City of Sacramento City Council

Meeting Date: 9/13/2011

Title: Entertainment & Sports Complex Technical Review Report

Report ID: 2011-00744

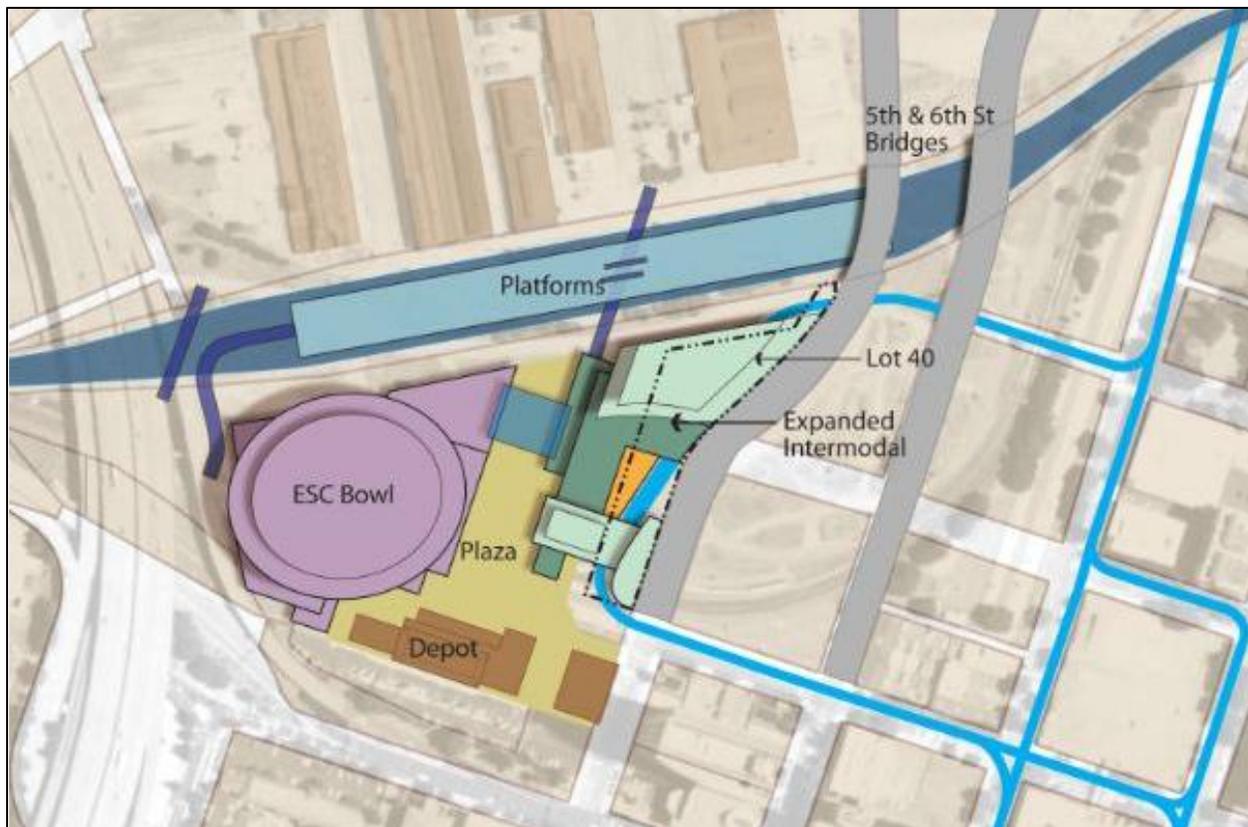
The City Technical Review team was charged with assessing the co-location of the ICON-Taylor Entertainment and Sports Complex plan with future Intermodal facilities. With the current constraints of existing and committed infrastructure, it became clear in early analysis that the ESC would need to shift westward from the ICON-Taylor proposal in order to accommodate the Intermodal requirements for bus and light rail and associated vehicular movements and would require additional land area identified as Lot 40 (refer to Figure 1). Furthermore, separating each facility, rather than creating a physical connection, allows for independent phasing and development funding. This de-centralized organization follows the recommendations made by the Urban Land Institute, Rose Center Fellowship Panel in both January and July 2011.

The City Technical Review Team's site concept organized the ESC and the Intermodal hub around a central linear plaza. With two intensive public facilities attracting large volumes of patrons, it is essential to provide public open space to service the needs of pedestrians before and after events. The City's site concept was validated by a committee of ULI experts in July of 2011, and this preferred concept should move forward in the final design phase.

Figure 2 - ESC Entrances: *The proposed location of the truck loading docks (west) and the main entrance (east) facing the plaza and Intermodal facilities.*

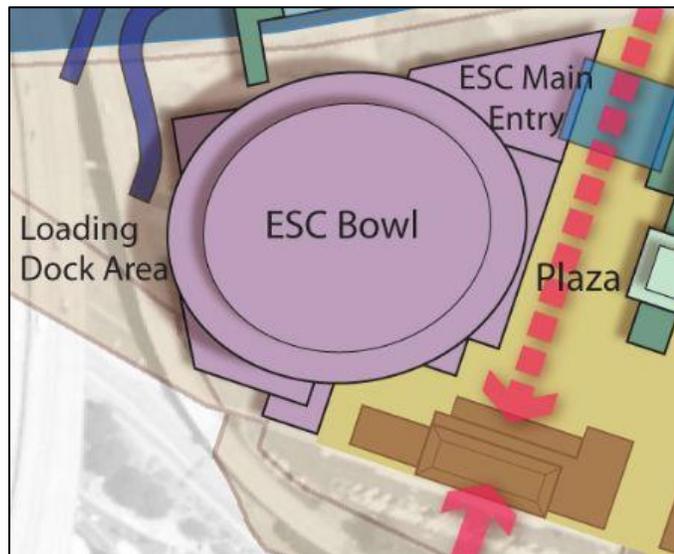
The City Technical Review Team has explored the option to lower the elevation of the ESC in order to mitigate the difference between street (plaza) level and the height of the main concourse. The main concourse is generally thirty-one (31') to thirty-five (35') feet above the event floor. Reducing the height of the concourse pushes the event floor below street level as well as the truck marshalling and loading dock area which must be on the same level as the event floor. Despite the ULI panel's recommendations in July, the City Technical Review Team concept does not currently recommend depressing the facility below grade due to the ground water conditions which exist on the site and the unknown cost impacts. However, further review should be undertaken before a final determination of impacts and benefits of lowering the facility can be assessed.

The internal function of the ESC requires the loading and truck marshalling area coincide with the stage end of the facility for performance venues. It is also customary to have the main entry to the facility opposite the stage end for large performance events. In consideration of these internal function criteria the servicing end of the ESC would remain to the west as proposed by ICON-Taylor. However, to avoid conflict with the access ramps to the passenger rail platforms that are currently under construction, the loading area may be moved to the southwest (refer to Figure 2). The entire area west of the ESC hosts numerous support columns for the Interstate 5 freeway that will need to be considered for circulation and access design.

Figure 3 – Depot District with High Speed Rail: *The proposed location for the future California High Speed Rail (HSR) terminus is shown east of 6th Street including platforms (green) and station (blue) with a plaza connection from the HSR station to the rest of the intermodal facilities (green).*

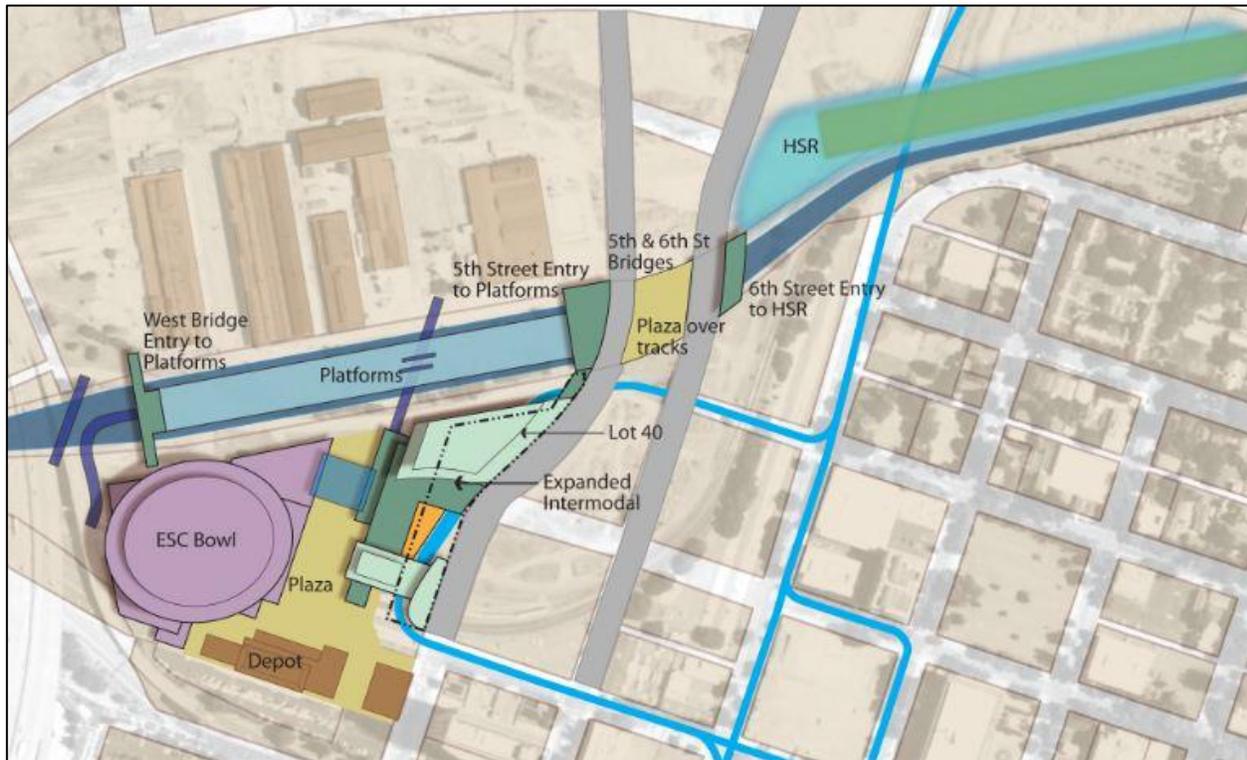
Based on City staff analysis and the ULI panel's recommendation, the Sacramento Intermodal Transit Facility (SITF) should shift east to encompass Lot 40, which is privately-owned, and a portion of the City-owned property identified as Parcel 'B'. A conceptual site plan is illustrated in Figure 3, which shows the SITF area adjacent to 5th Street situated between H and F Streets. As discussed in more detail in the Transportation section of this report, the SITF would include bus, light rail, commuter rail, and passenger drop-off. Future high speed rail service would now be located east of 6th Street, eliminating the need for raised tracks over the 5th and 6th Street bridges, which was seen as a major aesthetic impediment to the District and Central Shops. The individual components of the SITF would be linked along the spine of the rail corridor, creating an active transportation district rather than a single large facility.

Staff's proposal locates high speed rail at the east edge of 6th Street with a new public plaza above the tracks, bridging 5th and 6th Streets and a future 5th Street entrance to the Amtrak platforms currently under construction. This would provide a direct circulation connector joining the new Intermodal terminal at 5th Street with the future high speed rail Terminal at 6th Street (see Figure 3). The north and south edges of the plaza should be activated with pedestrian friendly programmed uses and façade articulation. As this Intermodal area develops, the design of buildings facing the plaza as well as those adjacent to 5th and 6th Streets will be critical in order to activate the area and to create an inviting approach into the Railyards. This arrangement allows for a more cost-efficient development pattern and creates greater opportunities for commuters and visitors alike to experience an active, energized Railyards and Depot District with its mix of retail, entertainment and transportation.

Figure 4 – Public Plaza: *Proposed public plaza, which establishes a view corridor between the Historic Depot and the Railyards' Central Shops, and acts a gathering place for both ESC events and the Intermodal services.*

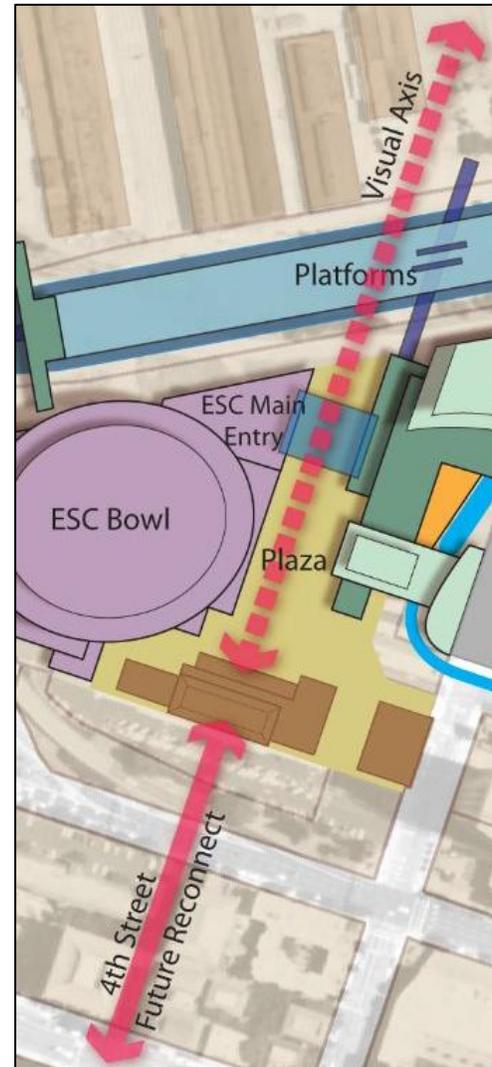
As shown in Figure 4, the central public plaza would align with the predominant axis of the Historic Depot as a visual extension of 4th Street. This would allow a clear visual relationship between the Historic Depot and the new passenger station facilities and Historic Central Shops beyond. Furthermore, it helps avoid having large structures massed directly behind the Depot. This central spine enables the expanded Intermodal facility to develop around a linear pedestrian space defined by the Depot, Intermodal extension and the ESC.

To address the large massing of the ESC, one concept proposed by the City's Technical Review Team allows the linear promenade, extending north from the Depot plaza, to ascend up to the main entry of the ESC on the west flank, and an upper level entry to the Intermodal while giving the patron a broad view of the Railyards' Central Shops buildings beyond and passenger facilities in the foreground. With the rise of the plaza towards the tracks, at approximately sixteen feet above existing grade, accommodation could be made for additional parking serving either ESC or Intermodal patrons. However, any rise in the plaza area would need to ensure that it does not block the public's views of the Historic Depot and Central Shops which are key assets of the area.

Figure 1: ESC Trip Distribution

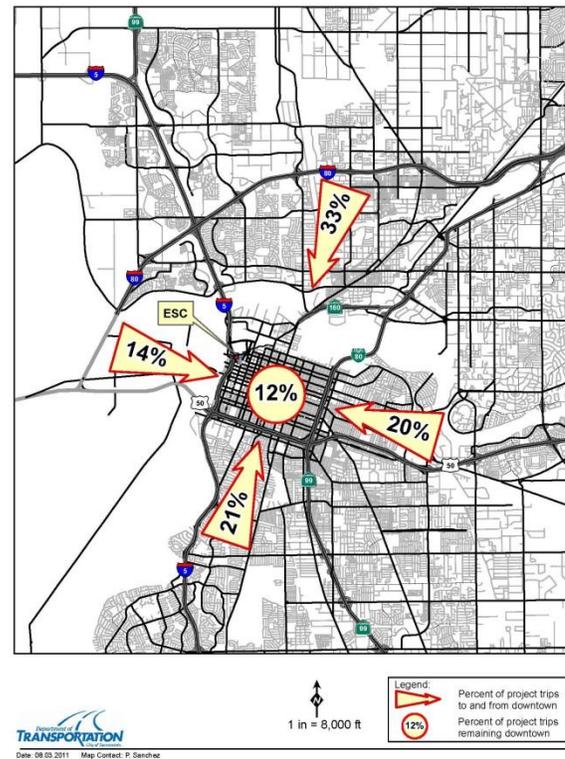
For planning purposes, the ESC trip generation can be estimated based on the number of seats and expected vehicular occupancy. It is estimated that between 10%-20% of event attendees will use light rail as their mode of transportation, 10% will use other modes such as buses, bicycling or walking, and the remaining 70%-80% will use private vehicles. FHWA studies indicate that a “vehicle occupancy factor of 2.5 persons per vehicle represents a common assumption”. With an 18,594 seating capacity, assuming a vehicle occupancy factor of 2.5, and assuming a sold-out event, approximately 5,200 to 6,000 vehicles will travel to and from downtown Sacramento on a major event day. These are the number of vehicles that would need to be accommodated with parking.

Based on current traffic patterns and previous studies, project trip distribution is estimated as shown on Figure 1. In summary approximately 33% of trips are assumed to be arriving from the north, 14% from the west, 21% from the south, and 20% from the east. Approximately 12% of the trips are expected to be generated within the downtown area.

Figure 2: Downtown Off-Street Parking

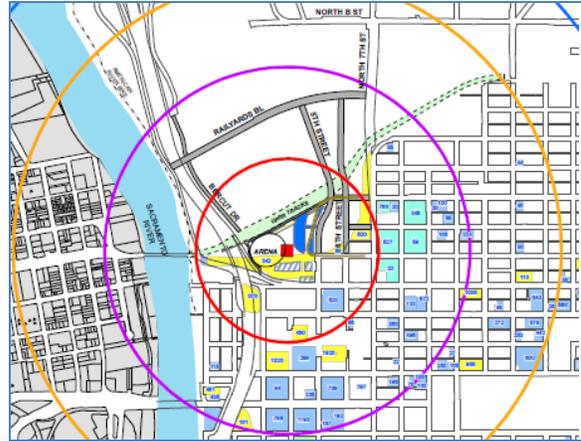
The available off-street parking (garages and lots) within the downtown area within a walking distance of $\frac{1}{4}$, $\frac{1}{2}$ and 1 mile radius from the ESC are shown diagrammatically in Figure 2 (source: Parking Division, 7/26/2011). The number of available off-site parking spaces within $\frac{1}{4}$ mile radius from the ESC site is 3,404 spaces while the number of available parking spaces within $\frac{1}{2}$ mile radius is 17,433. These spaces include City, County, State, and privately owned surface parking lots and garages. The majority of the available off-street parking is located south and east of the ESC and Intermodal facility site. Lot 44, located between 5th and 6th Streets and north of G Street has been identified as a potential site for a new parking garage with 900 parking spaces. This garage could be shared between the ESC, the planned County Courthouse, Intermodal facilities, and other uses. The ESC will also need about 1,500 to 1,800 premium parking spaces which could be located in this new parking garage. If the garage were not constructed until after the ESC opens, premium parking would need to be provided within 2 blocks.

Although there appears to be adequate parking capacity within garages and lots within a $\frac{1}{2}$ mile from the ECS site, at this time, there is limited information available regarding the number of vacant parking spaces that may be available just prior to an event at the ESC.
